## Application No. A/TWW/78

Application Site : Minor Amendments to an Approved Development Proposal for Hotel

Subject of Application : TWIL 5 and Lot 429 in DD 399, Ting Kau, Tsuen Wan

# Update of the MLP since its TPB's approval on 7/3/2005

# L17 FLOOR PLAN

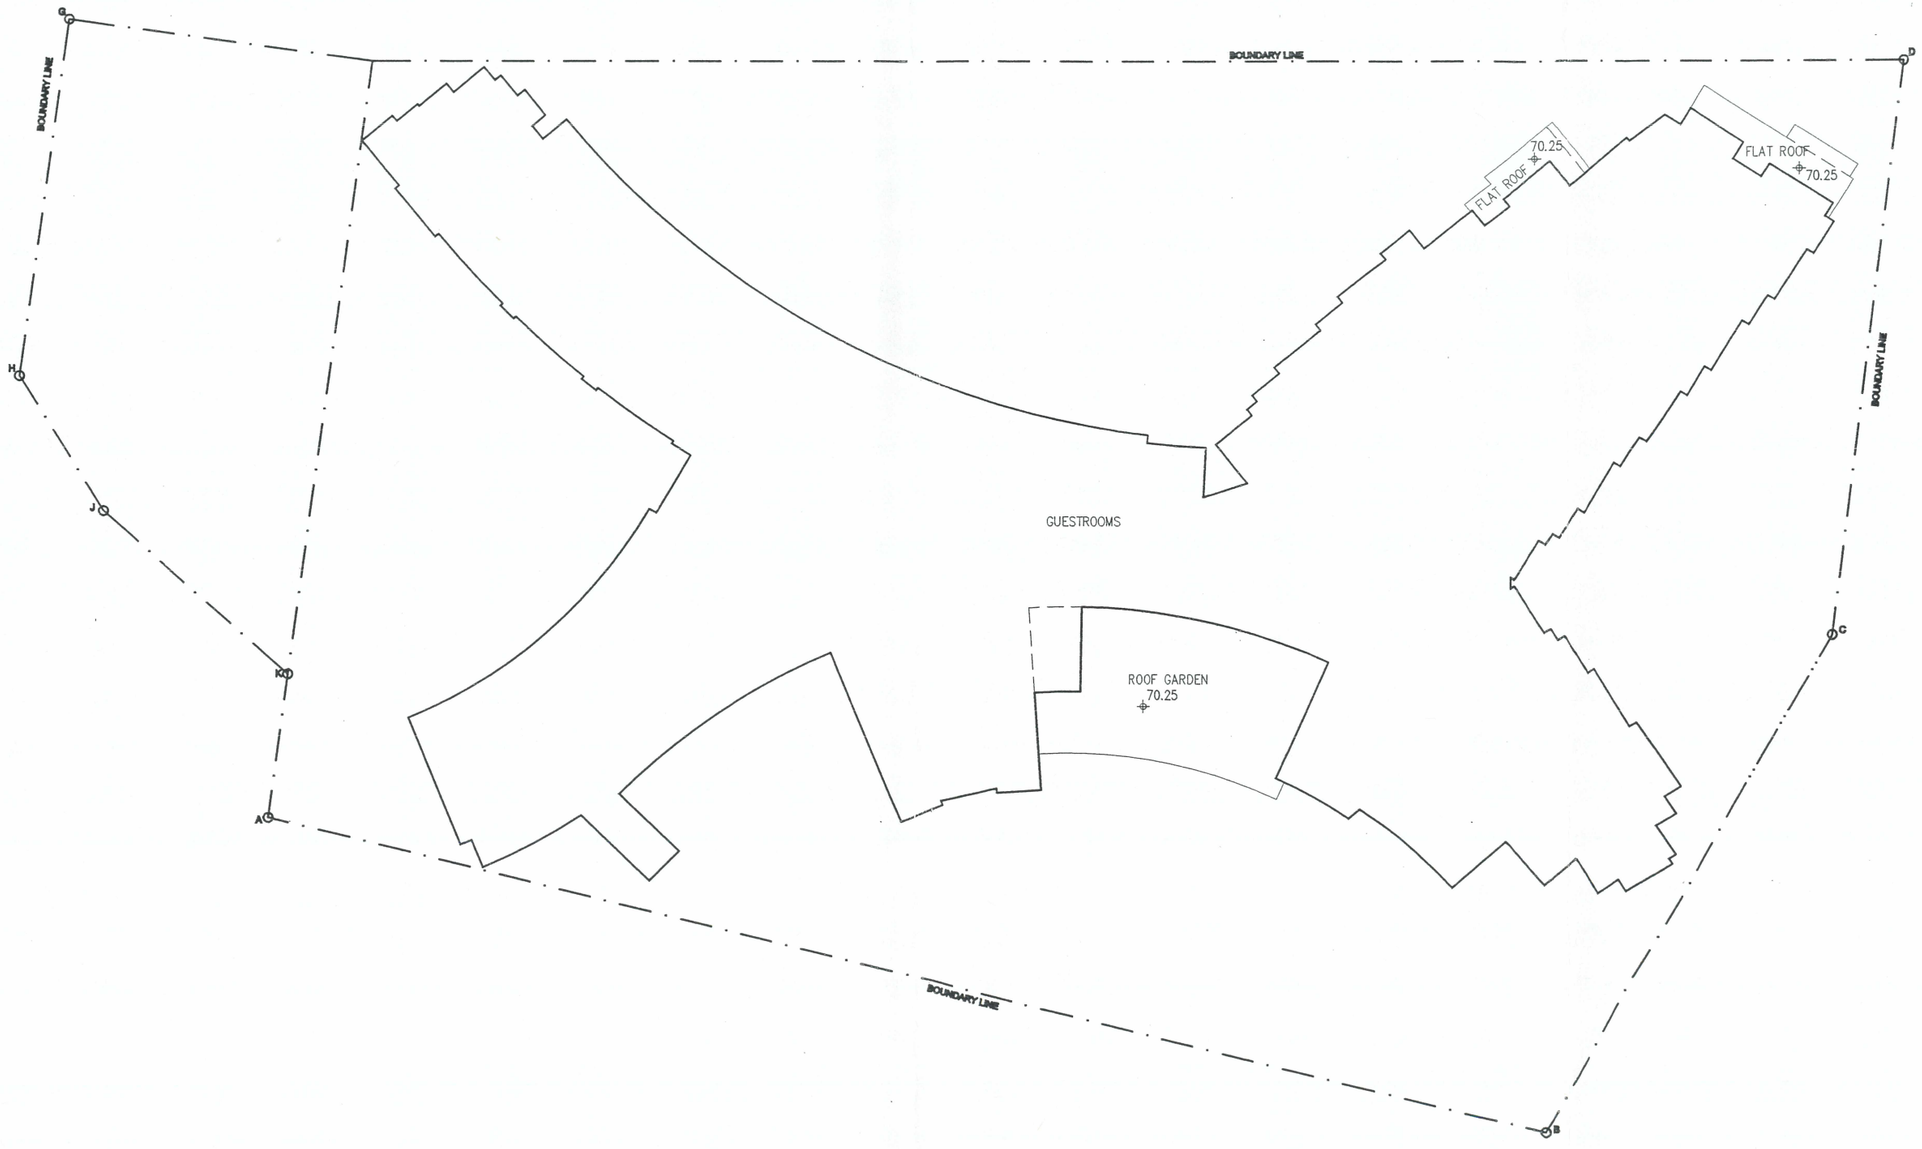
(PREVIOUSLY LEVEL 16 AS IN A/TWW/78 APPROVED ON 7.3.2005)
